EL PASO COUNTY, COLORADO

FRONT RANGE-MIDWAY (FRMW) WIND/SOLAR ENERGY OVERLAY (WSE-O) PLAN

WIND/SOLAR ENERGY GENERATION OVERLAY (WSE-O) PLAN (WSEO-17-001) FOR THE FRONT RANGE-MIDWAY SOLAR PROJECT EL PASO COUNTY, COLORADO **EXISTING STRUCTURES** WSEO-17-001 DISTRICT BOUNDARY And the state of t FEMA FLOOD ZONE A PROPOSED WSE-O FENCE _x _ x _ OPERATIONS AND INTERCONNECTION SUBSTATION ARRAY BOUNDARY MANAGEMENT - SOLAR MODULES ON TRACKERS TYPICAL, PROPOSED 115kV CIRCUIT SEE SHEET 12 & 13 FOR DETAILS THE PROJECT SUBSTATION WILL + NON-JURISDICTIONAL WATER FEATURES STEP UP THE POWER TRANSPORTED EXISTING 115kV CIRCUIT TO BE AVOIDED VIA THE UNDERGROUND COLLECTION LINES TO 115 KV DEPENDING ON THE FINAL POINT OF INTERCONNECTION PROPOSED 230kV CIRCUIT EXISTING 230kV CIRCUIT PRIVATE ROAD TO REMAIN OPEN PROPOSED ELECTRICAL COLLECTION EXISTING ROAD CENTERLINE SEE SHEET 13 FOR DETAILS — — FEMA FLOOD BOUNDARY EXISTING 115kV -TRANSMISSION LINES DC TO AC INVERTERS TYPICAL OF 33 SEE SHEETS 15 & 16 FOR DETAILS EXISTING R.O.W. (NO ROAD) WATER FEATURE TO 100 BE AVOIDED / DRAINAGE BASIN/POND (TYPICAL) RÁNCHO COLORADO BLVD. METEOROLOGICAL STATION TYPICAL OF 5 SEE SHEET 14 FOR DETAIL THE DISTANCE BETWEEN TH

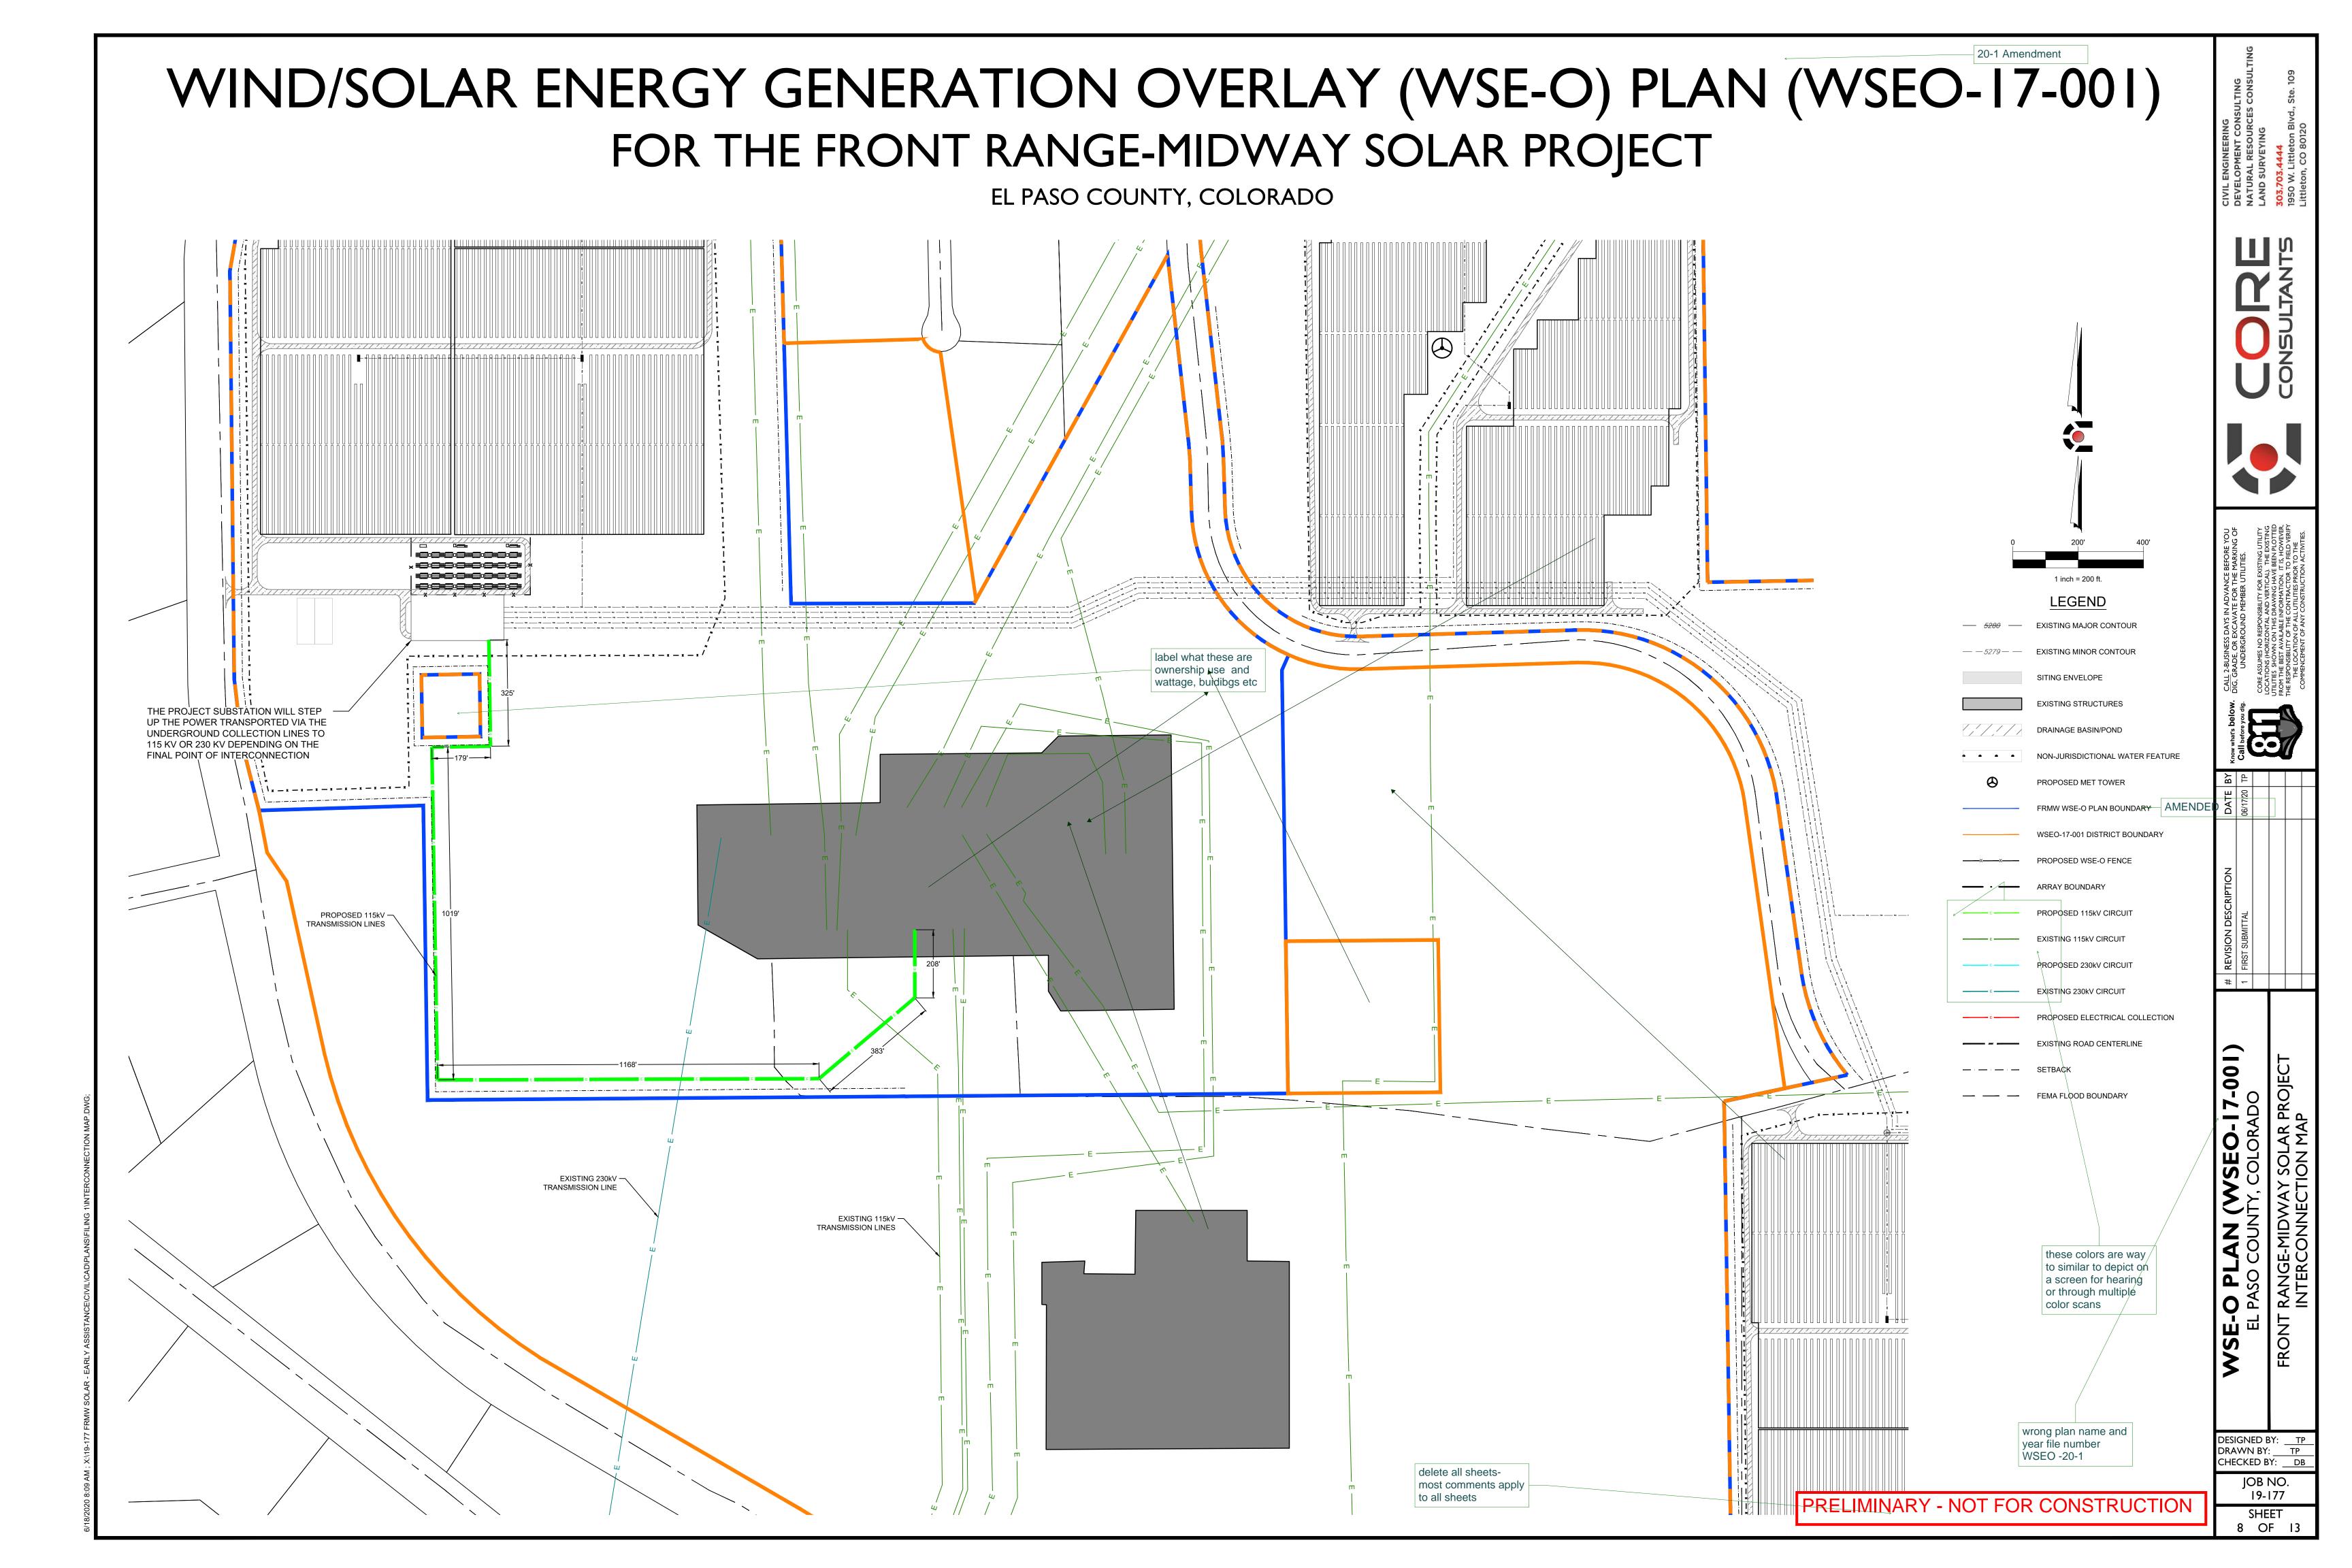
panels relocated here

panels expanded

previous panels removed and relocted to

11 OF 13

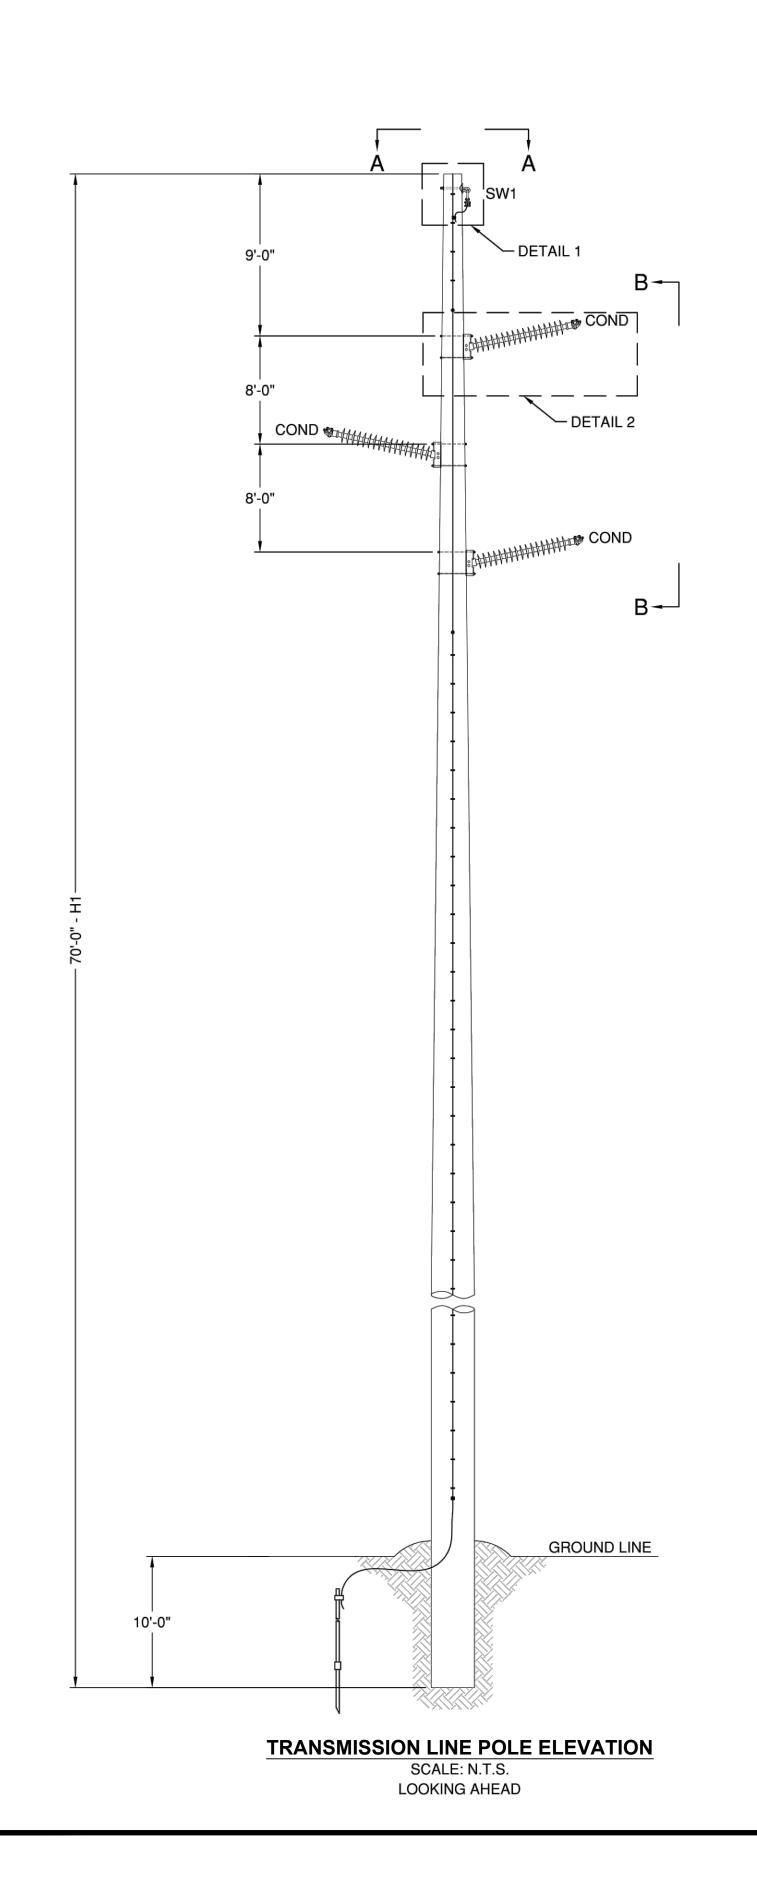
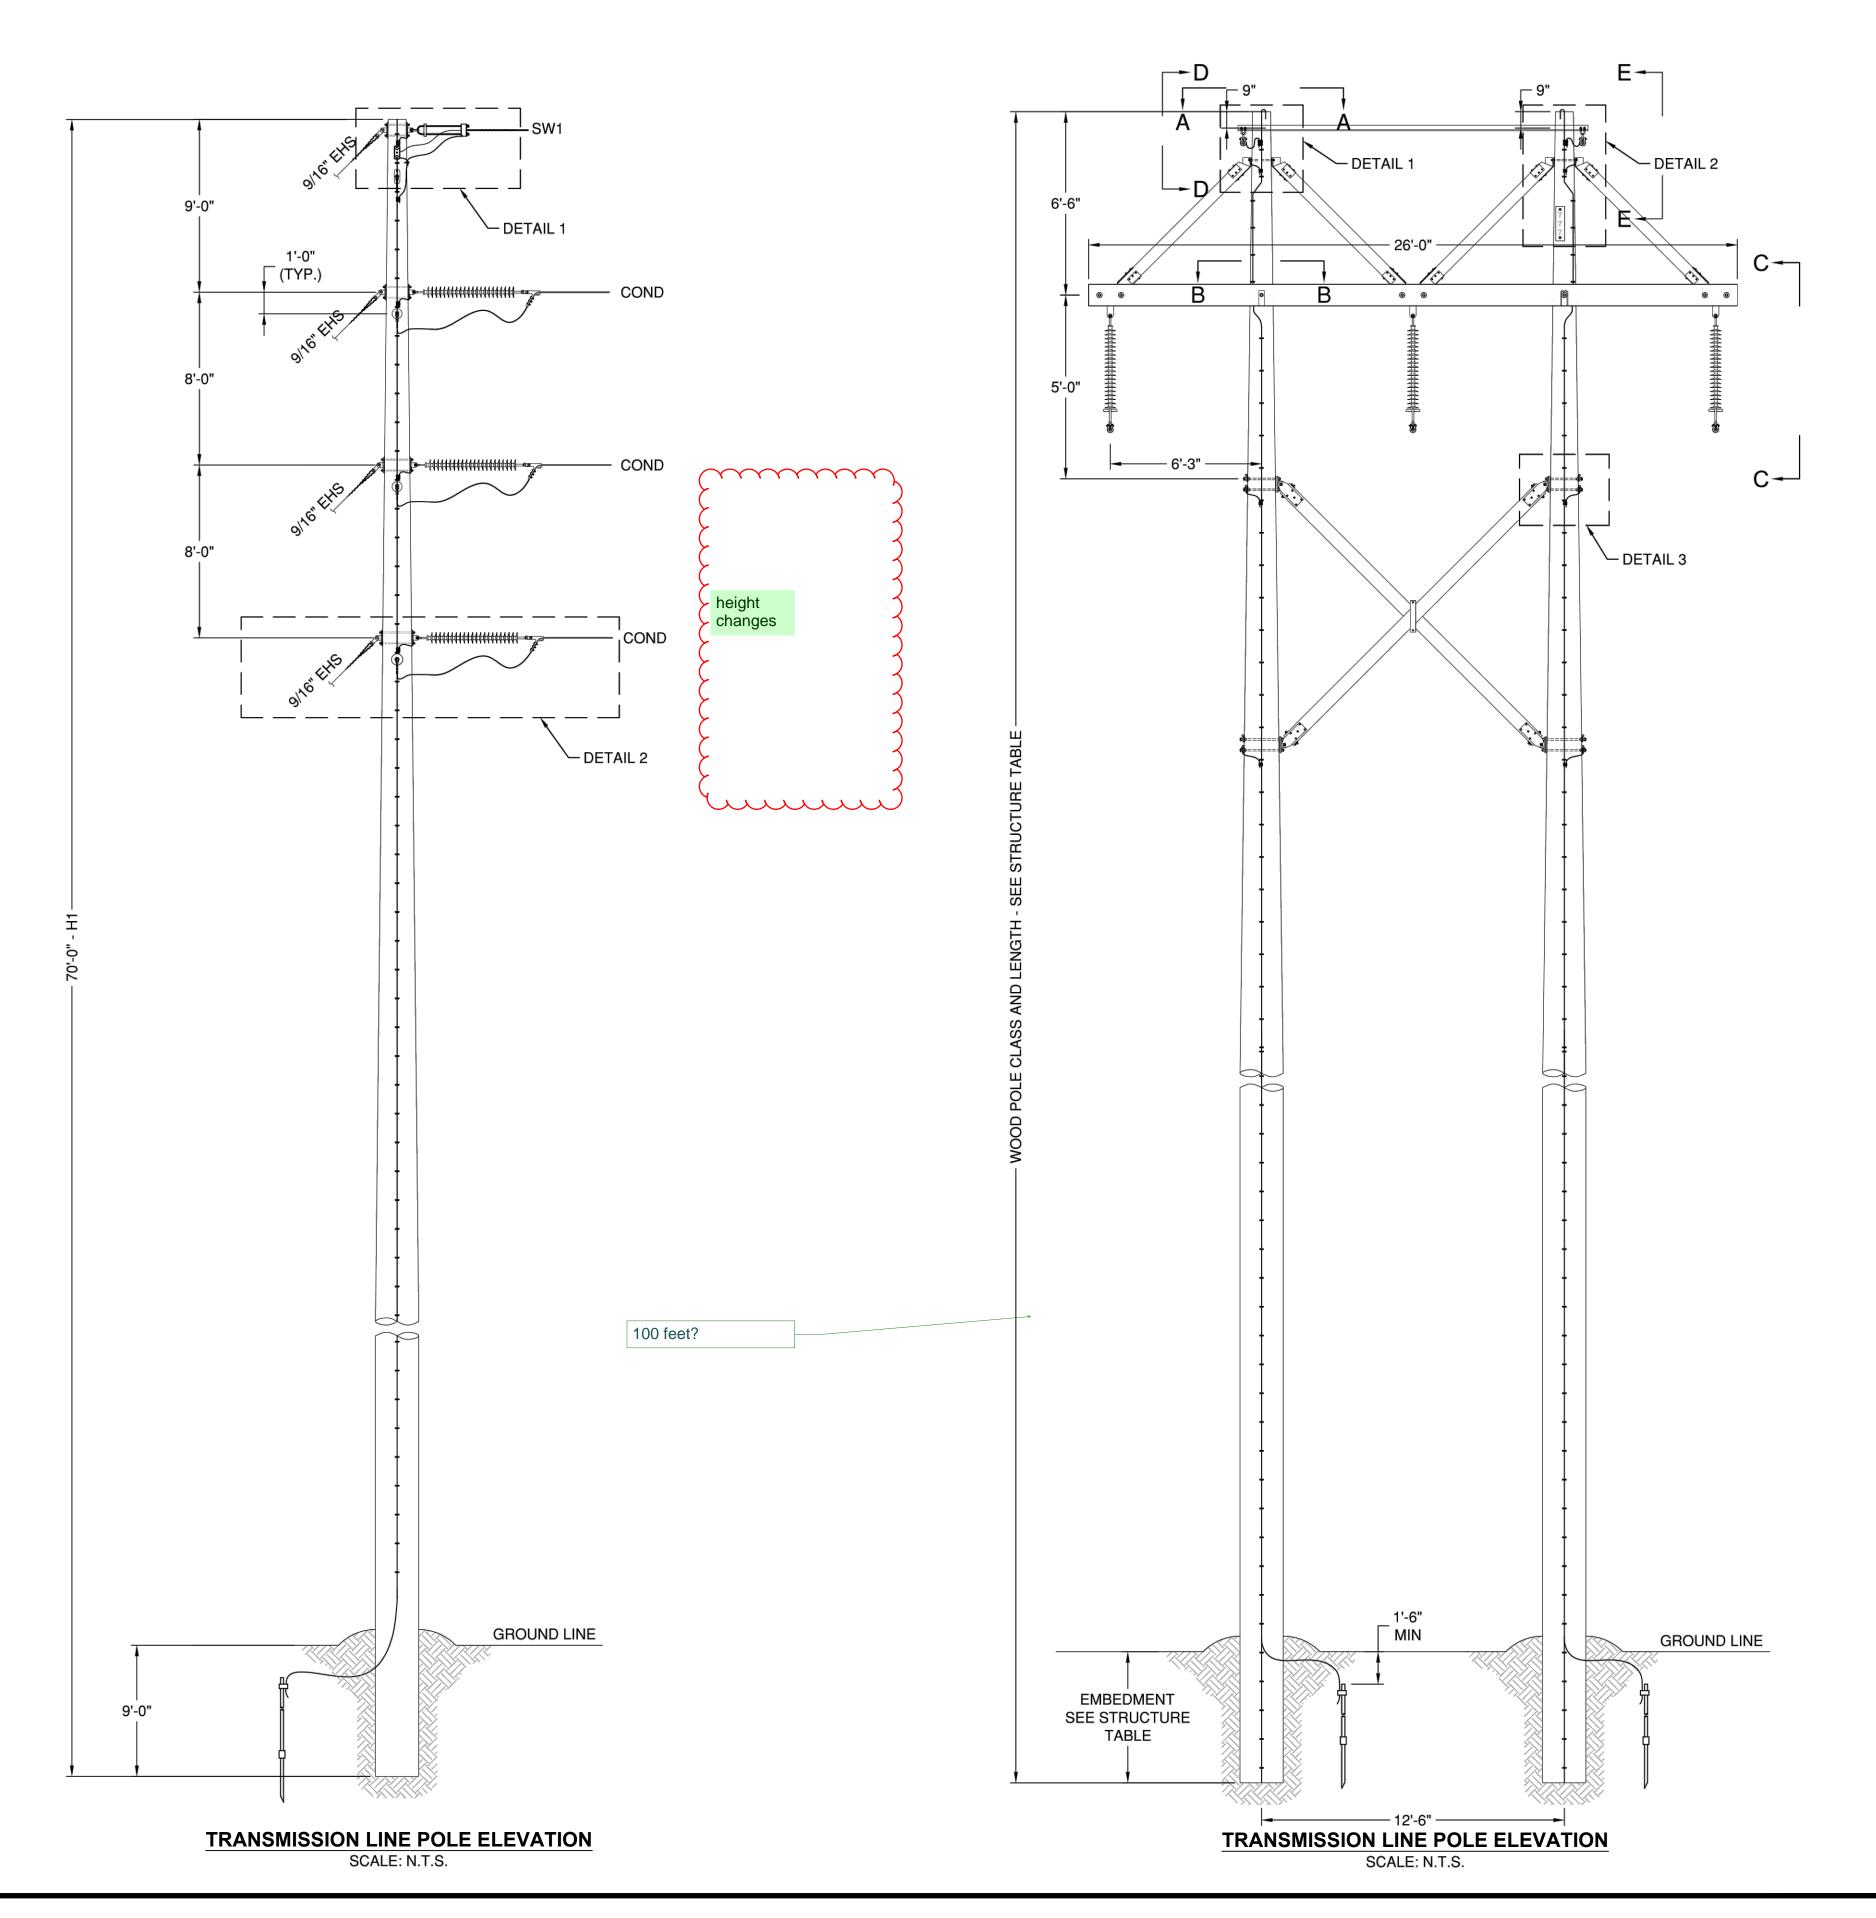
height changes

height changes
